# STAFF REPORT

## SAUSALITO PLANNING COMMISSION AND HISTORIC LANDMARKS BOARD

**Project** Casa Madrona Renovation / 801 Bridgeway  
Design Review Permit and Nonconformity Permit  
DR/NC 10-377

**Meeting Date** October 26, 2011

2 PROFILE/ENTRANCE ELEVATION  
SCALE: 1/4" = 1'-0"

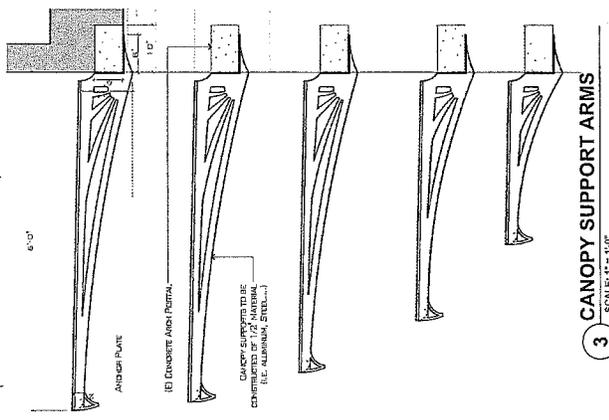
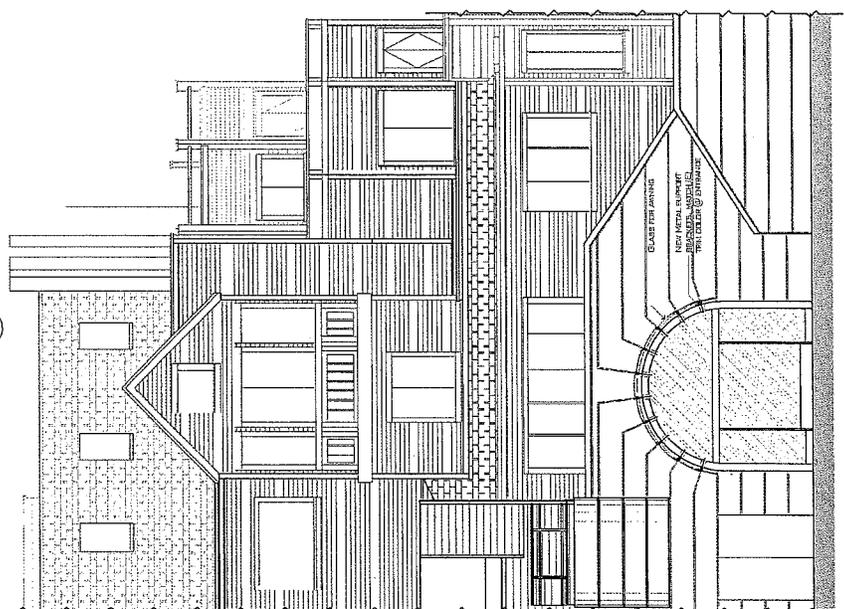
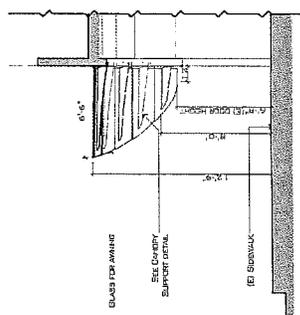
The applicant has worked with Staff and the HLB to submit an appropriate awning design for that site and location. However, the requested awning as submitted still does not comply with the City's awning standards. The awning as submitted would be located six feet eight inches above ground over the public walkway, whereas awnings are required, by Section 10.42.060.B of the Zoning Ordinance, to have an eight foot clearance above ground over walkways, for the purposes of pedestrian safety. Staff has created a Condition of Approval requiring the modification of the lowest point of the canopy to the required eight feet above ground (see **Exhibit D** for Conditions of Approval).

7. The applicant shall submit revised plans for the awning which provide at least eight feet of vertical clearance between the awning structure and the ground over the walkway.
